Revised Nevada Division of Environmental Protection BART Determination Review of NV Energy's Fort Churchill Generating Station Units 1 and 2

FIGURE 1

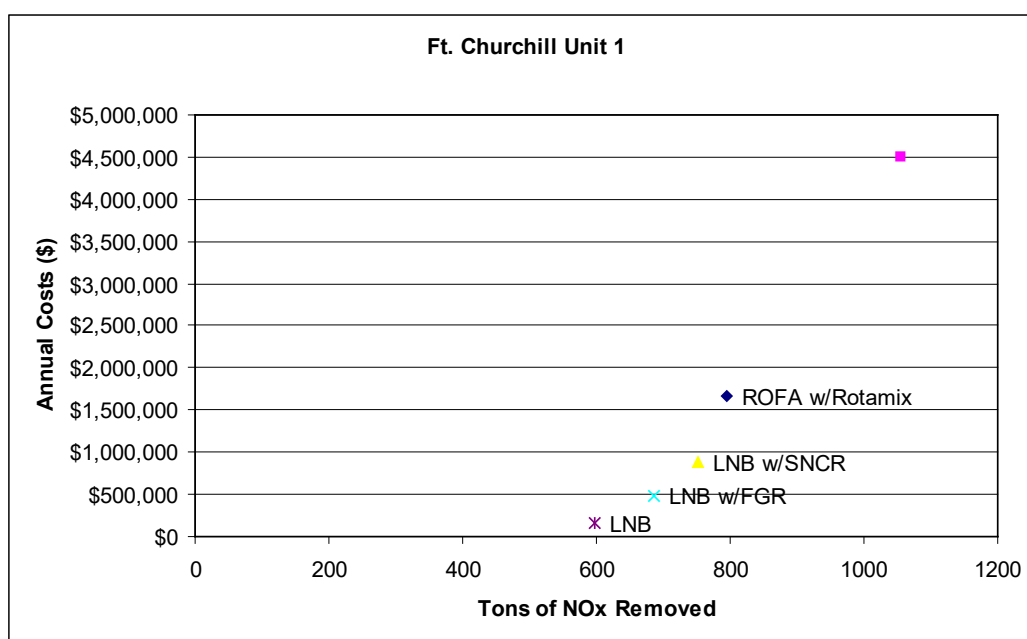
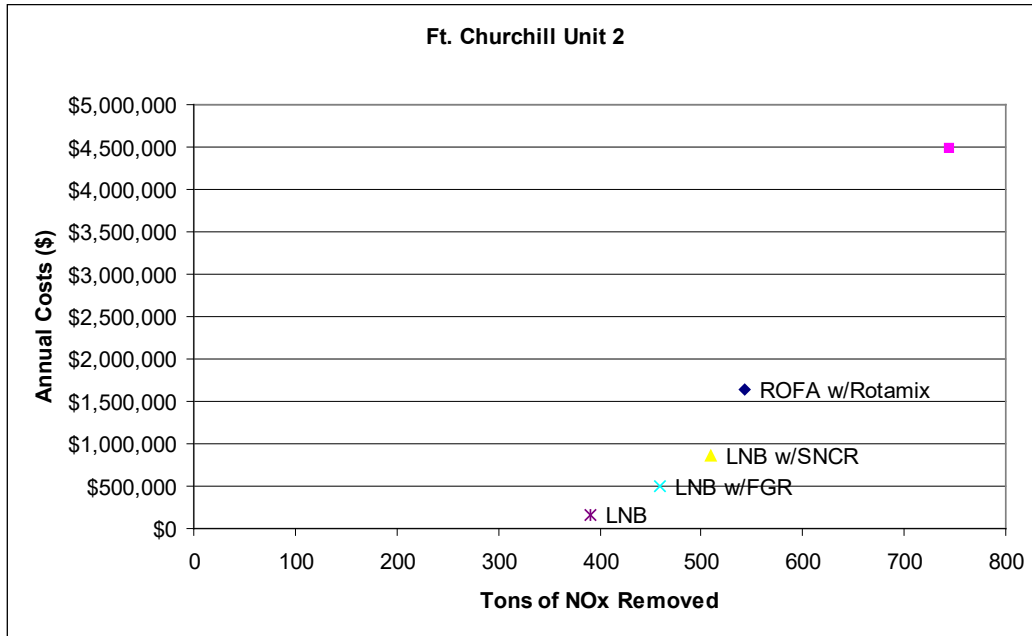
NDEP specifically reviewed the cost per ton of NO_x removed for each unit at Fort Churchill and determined that installation of LNB with FGR meets the BART criteria, with associated first

year costs of \$716 and \$1,070/ton of NO_x removed for units 1 and 2, respectively. These values are considered cost effective. The cost data from the tables above are presented graphically in Figure 1. NDEP also considered the Clean Air Act factors of expected emission rates, emissions performance levels, expected emissions reductions, energy impacts, non-air quality environmental impacts and modeled visibility impacts in Nevada's control technology determination. NDEP concluded based on a review of the economic analysis that the \$/ton of NO_x removed increased significantly for LNB with SNCR, ROFA and SCR technologies with only slight improvements in visibility.

Based on this review, NDEP concludes that for NO_x the installation of LNB with FGR with an emission level at 0.20 lb/MMBtu for unit 1 and 0.16 lb/MMBtu for unit 2, on a 12-month rolling average, is BART.
